**Notice of a Meeting**  
**Dalworthington Gardens Planning and Zoning Commission**

**June 12, 2023 at 6:00 p.m.**

Notice is hereby given that the Dalworthington Gardens Planning and Zoning Commission will hold a public hearing on June 12, 2023 at 6:00 p.m., and the Dalworthington Gardens City Council will hold a public hearing on June 15, 2023 at 7:00 p.m., both of which will be held in the Council Chambers, 2600 Roosevelt Drive, Dalworthington Gardens, Texas to consider the following: A replat application from Vitex Developments, LLC for existing Block 3, Lot 10, changing to Eleanor Estates, Block 1, Lots 1-6, with approximate current addresses being 2601 California Lane and 2615 California Lane, Dalworthington Gardens.

Project Name and Address  
 ELEANOR ESTATES  
 DALWORTHINGTON GARDENS,  
 TEXAS

**BLUEGRASS DRIVE PLAN VIEW**

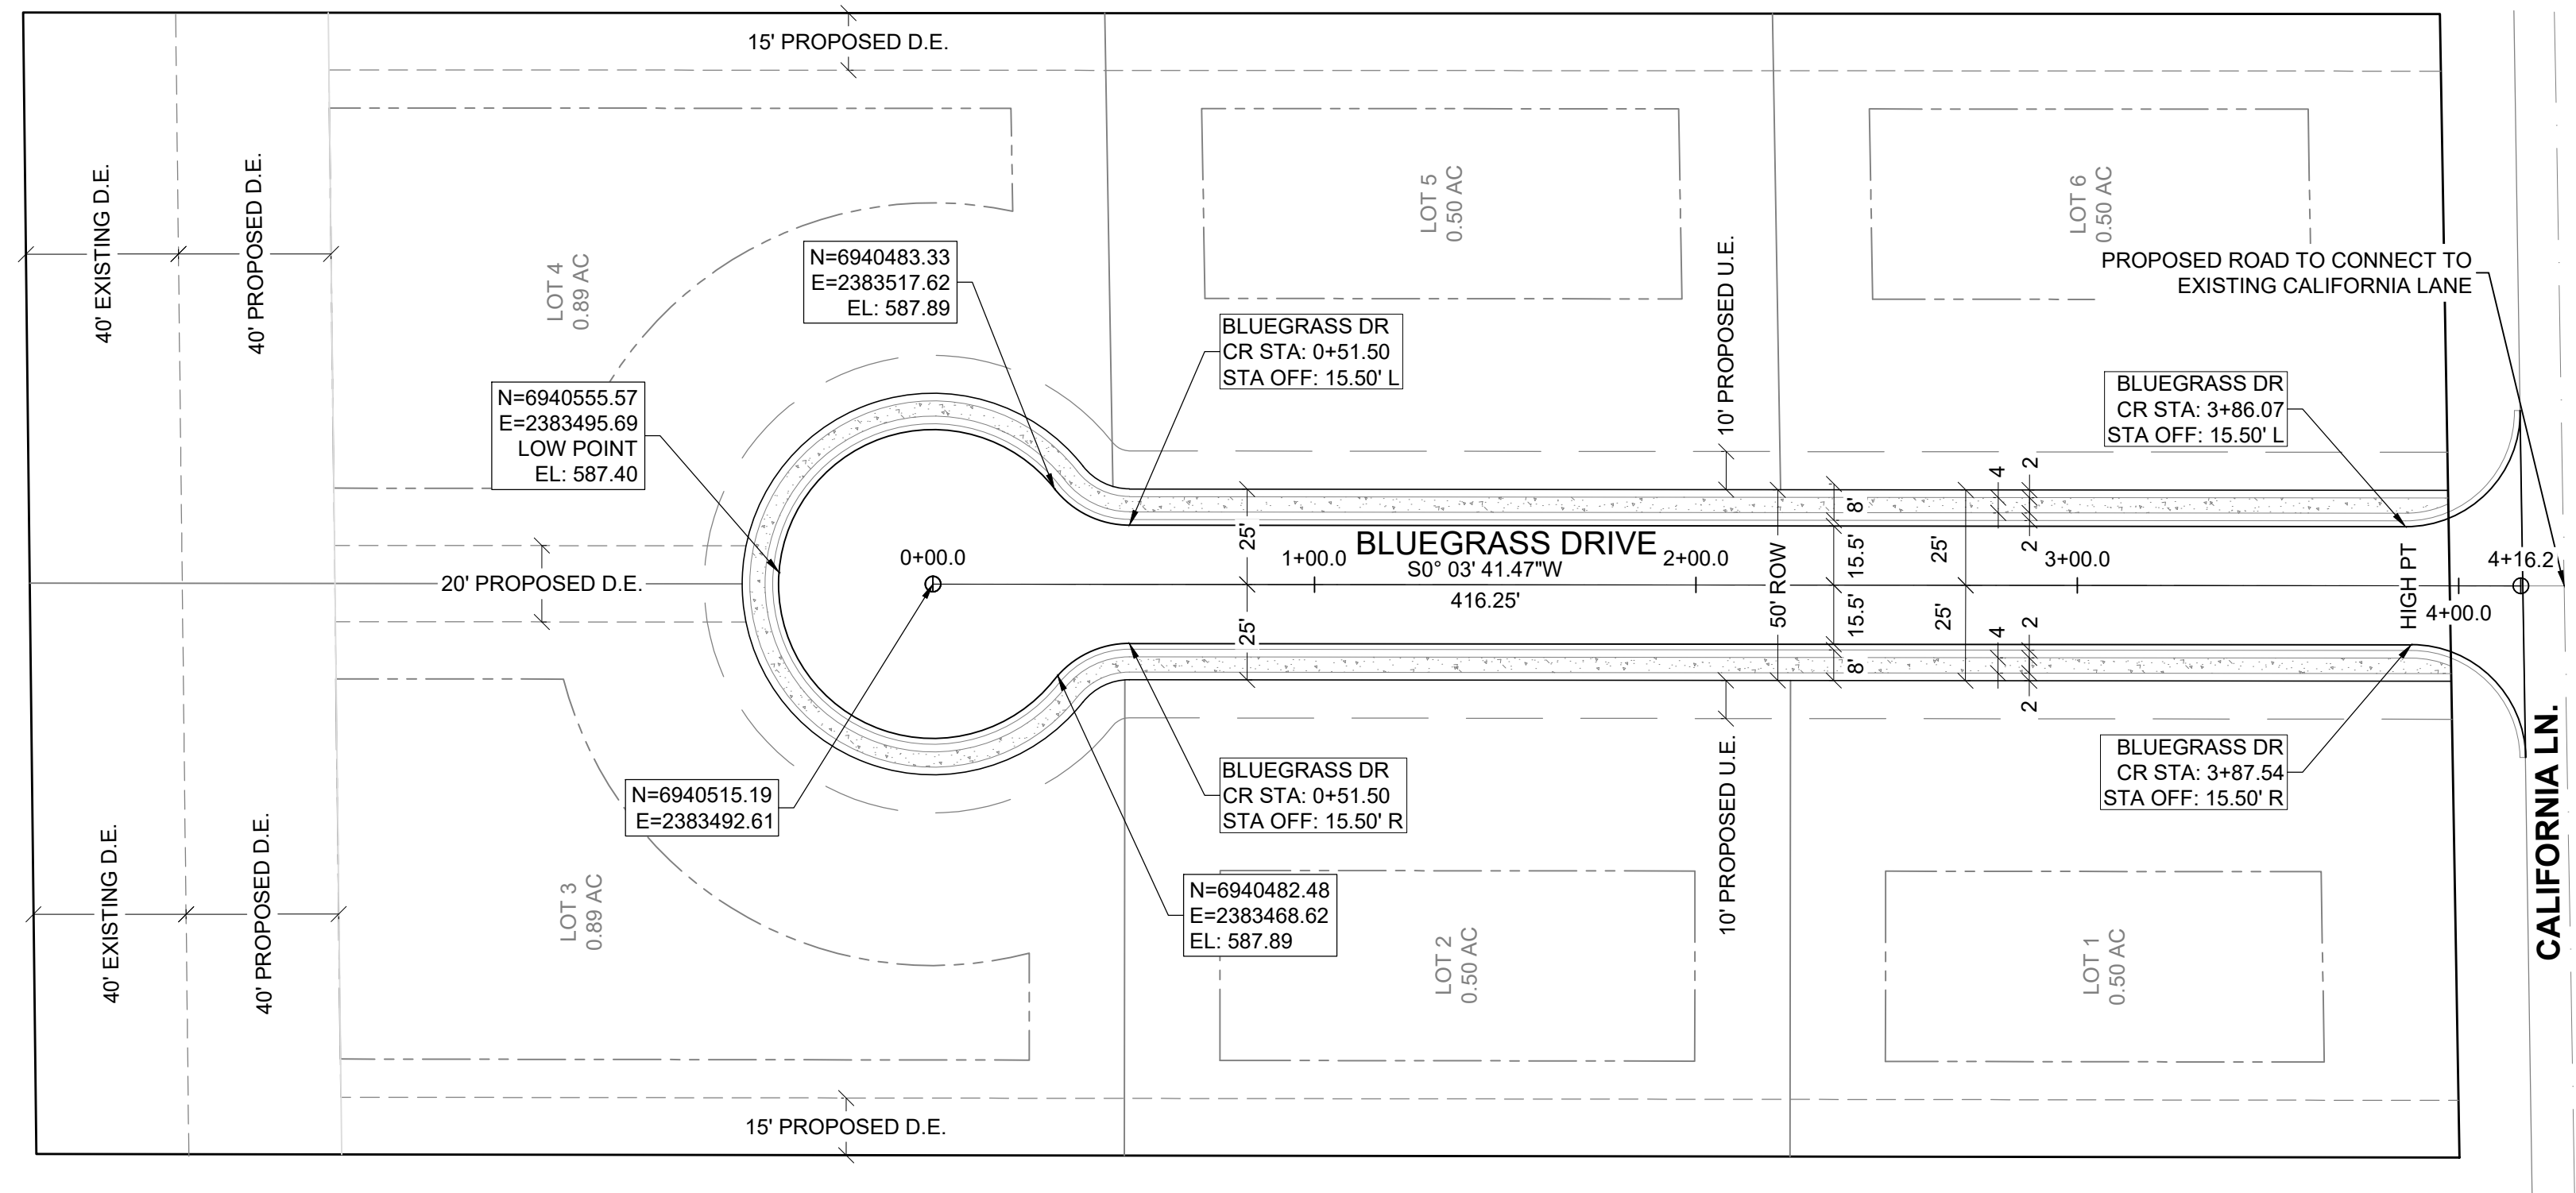
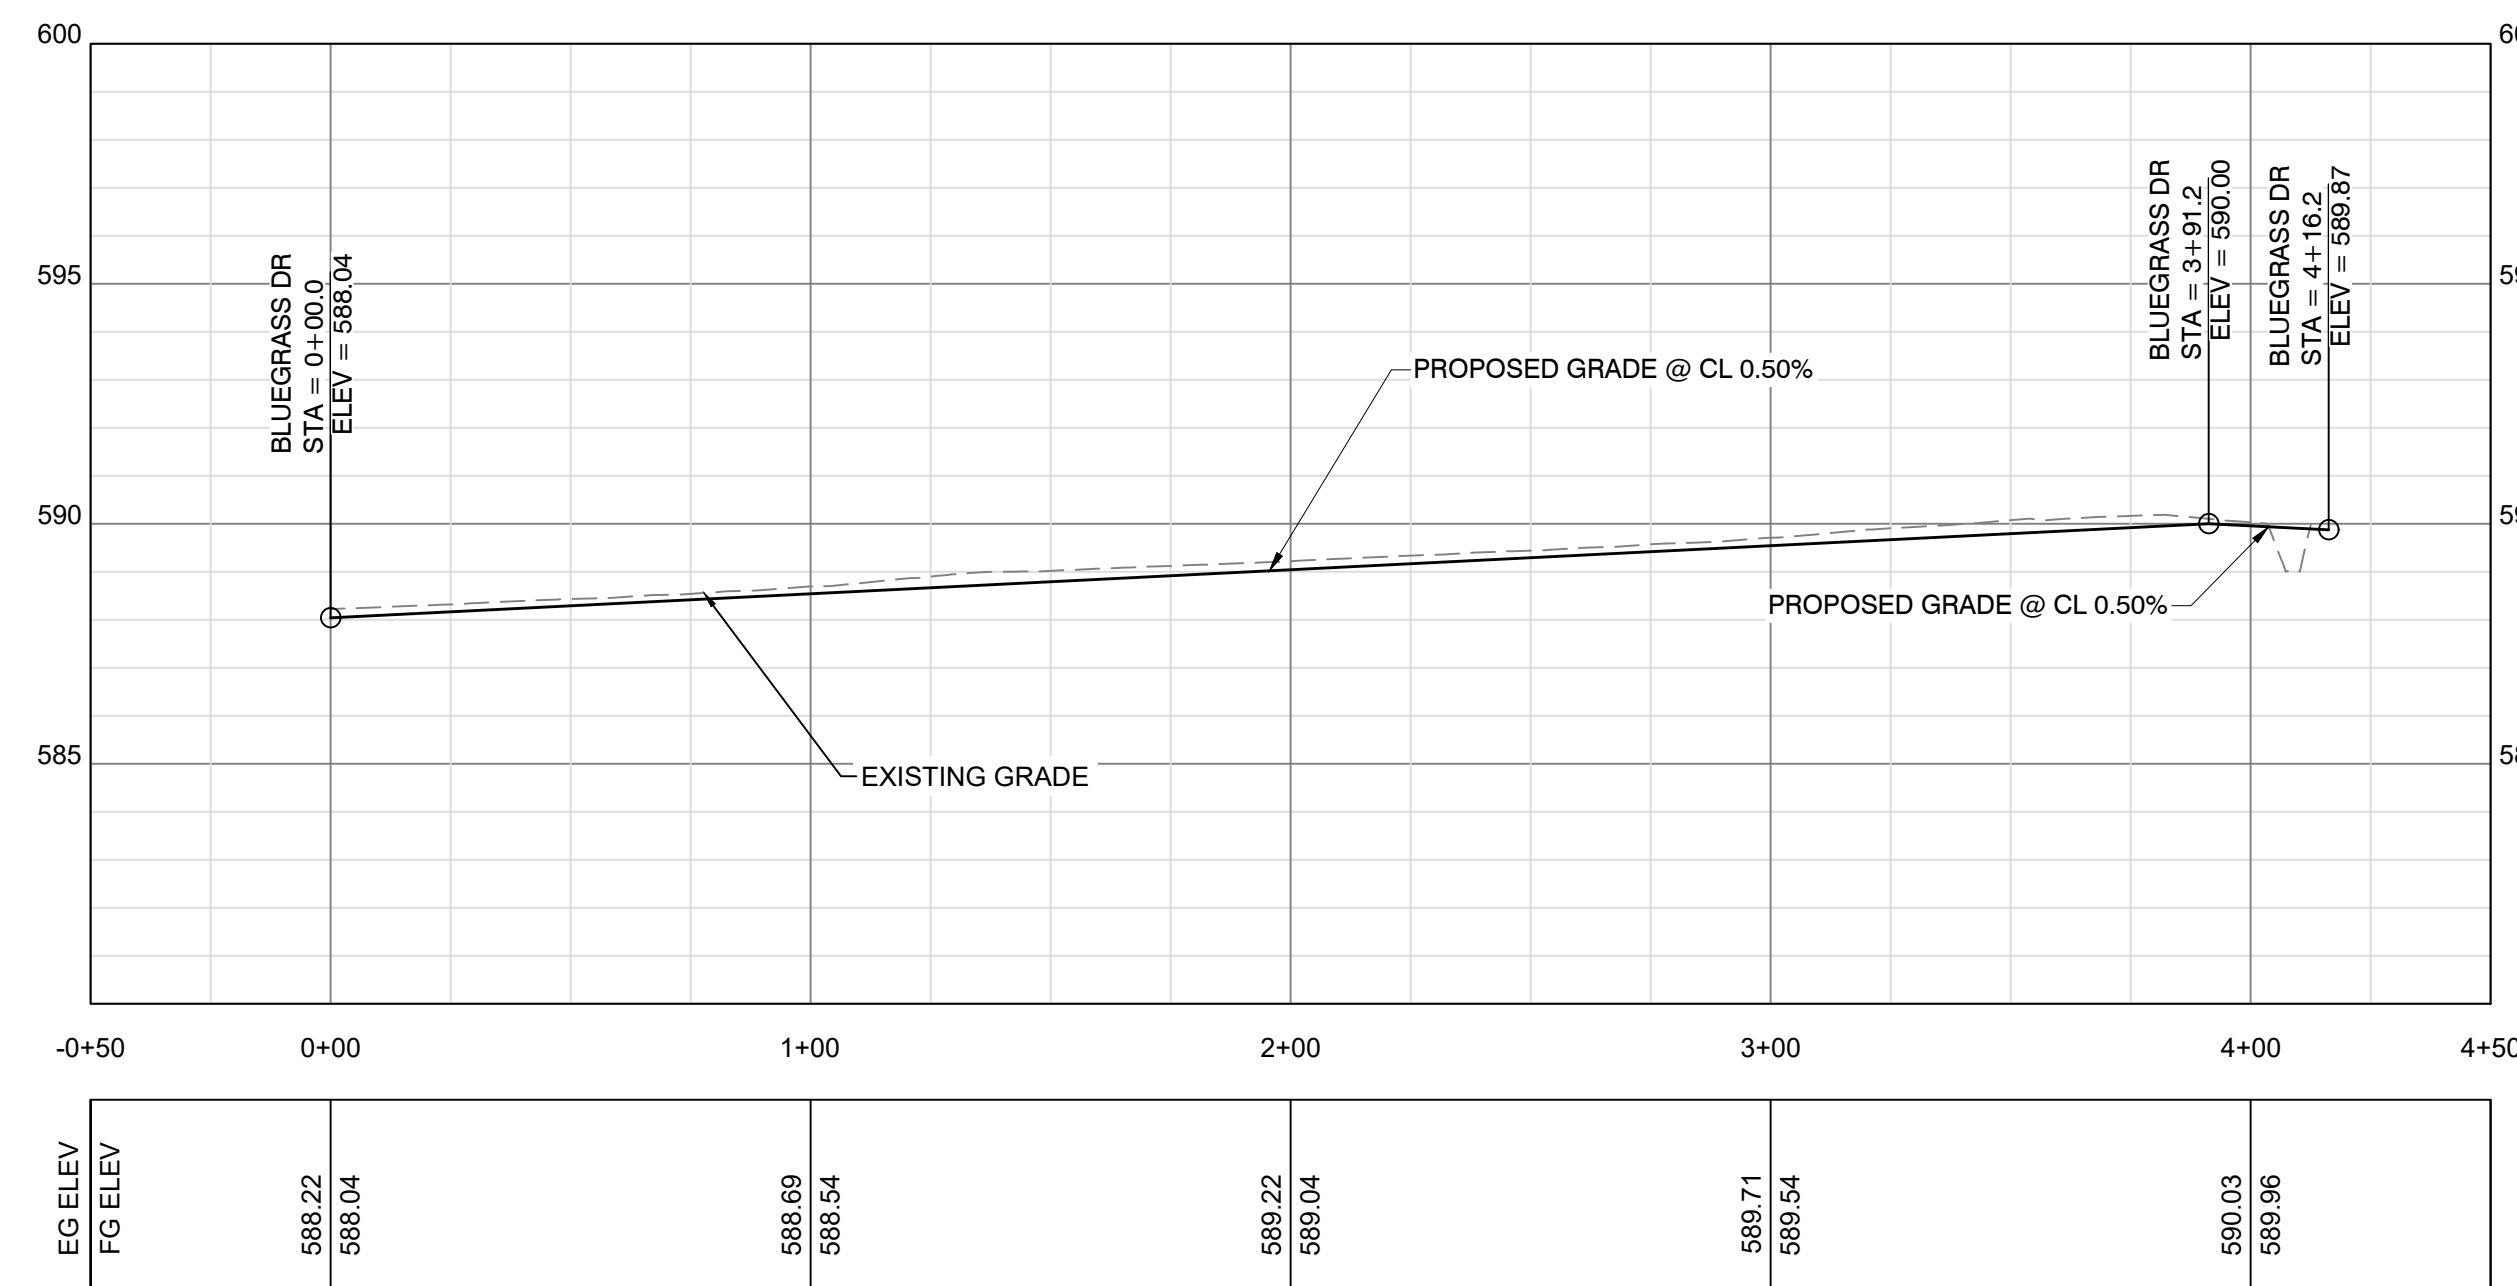
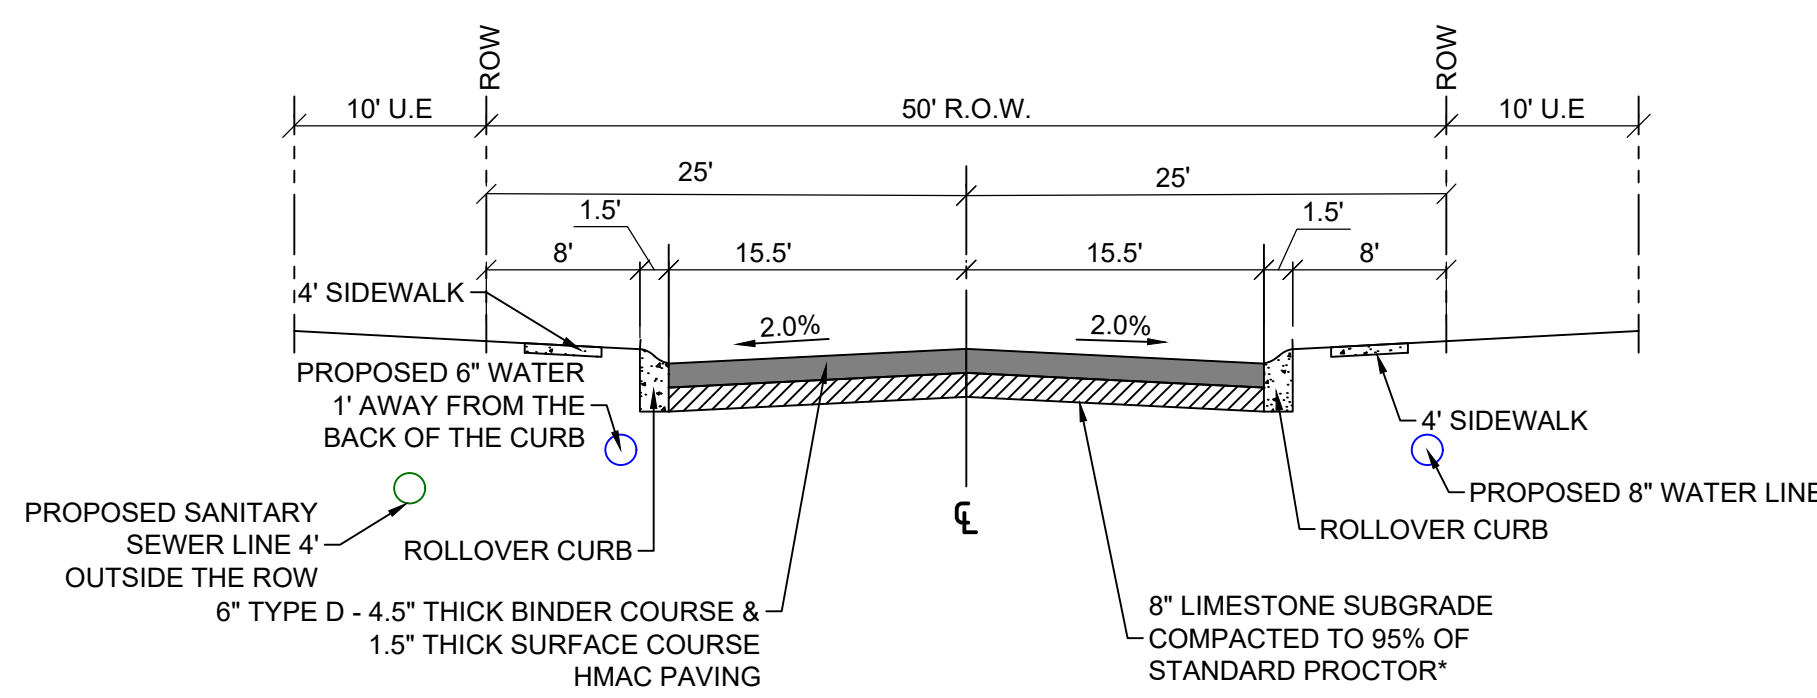
Please show sidewalk

Response: Sidewalk added to plans and a note also added that home owner/home builder will be installing the sidewalk in front of their property in the street R.O.W (Completed)

SHALLOW SANITARY SEWER MANHOLE	North Central Texas Council of Governments	STANDARD SPECIFICATION REFERENCE
		33 39
	DATE	STANDARD DRAWING NO.
	10/20-D210

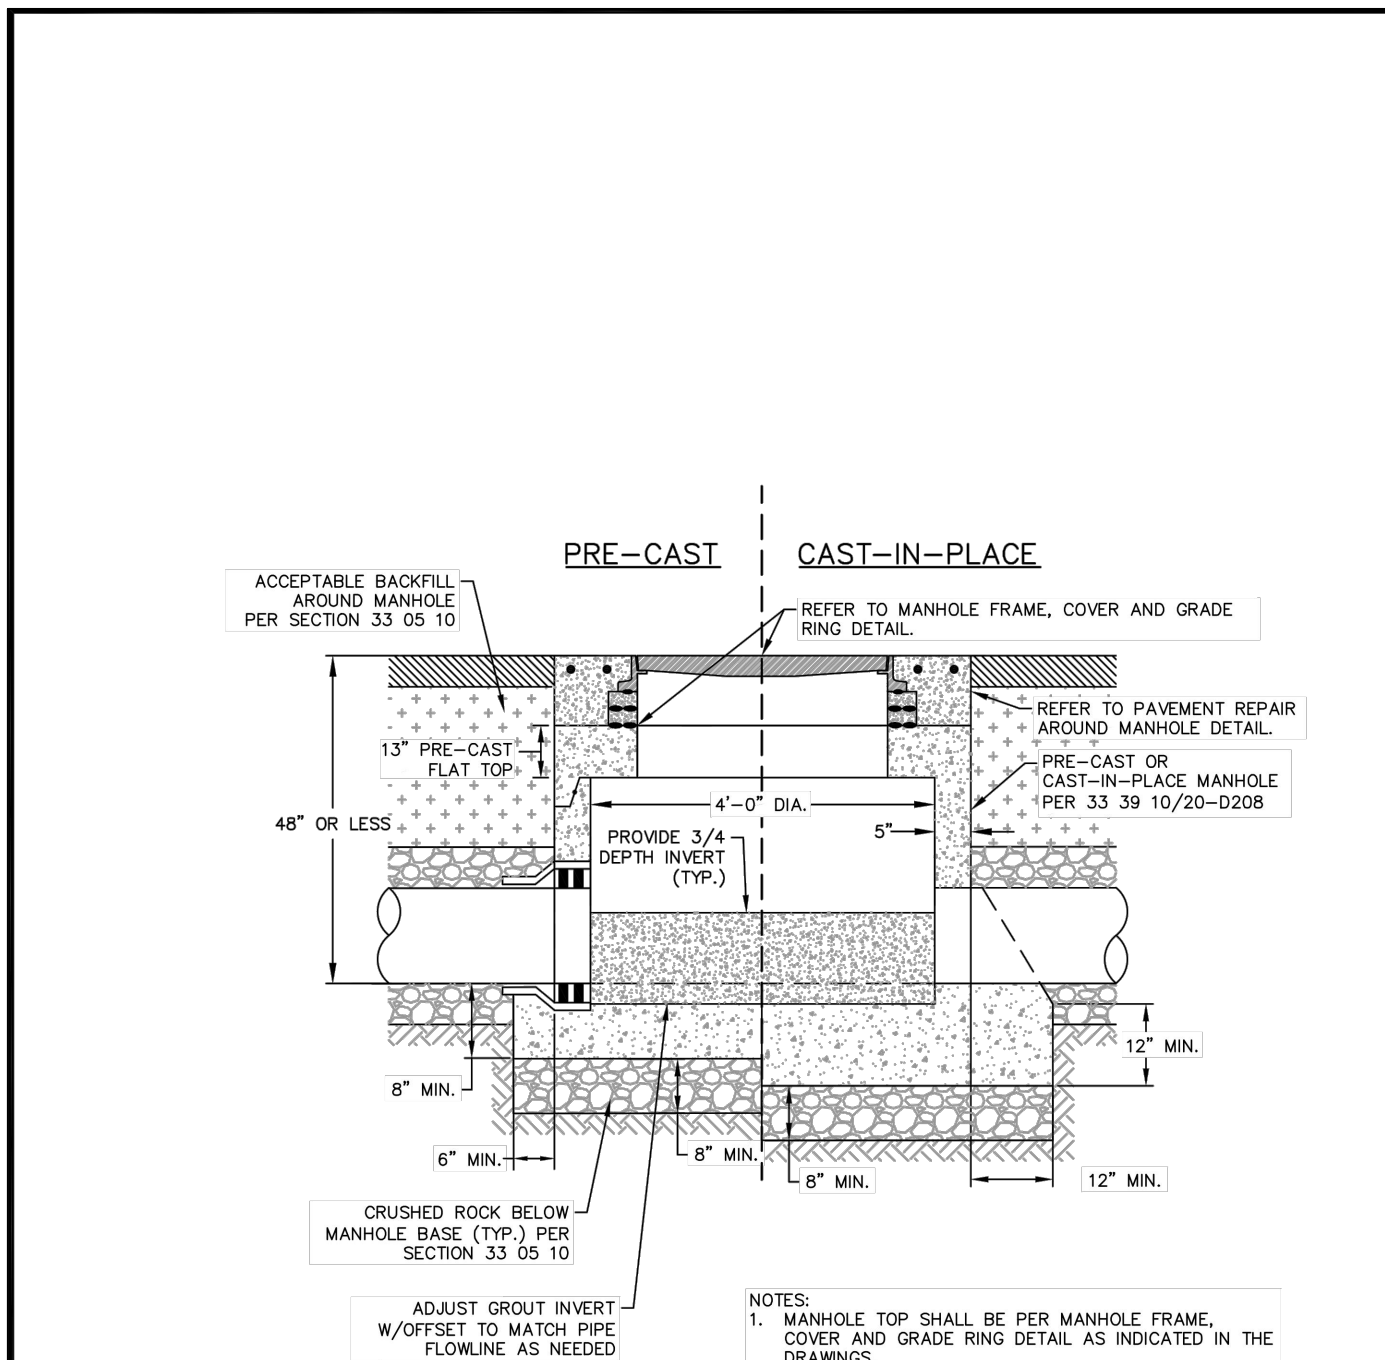
Please verify shallow depth MH with PW department.

**Response: we have added a detail for shallow manhole. We will also contact PW about this manhole** (Completed)
